New Side Panel and Outer Casing

Side Panel

New grommet P/N 3865006

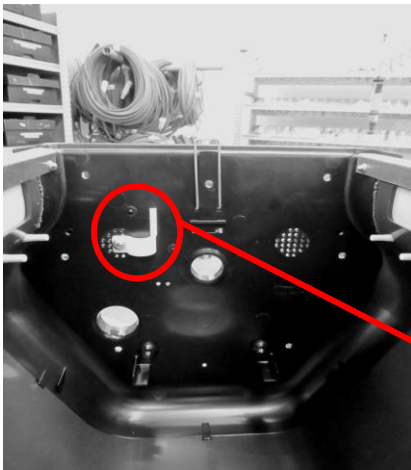
As part of our quality improvement policy, we are introducing a new side panel which includes a grommet (see illustration) the grommet prevents cable ruptures at the cable entry point.

- a. When an existing side panel needs to be replaced, replace it with the same type of side panel.
- b. When an existing outer casing needs to be replaced, use a new outer casing and new side panel with grommet.
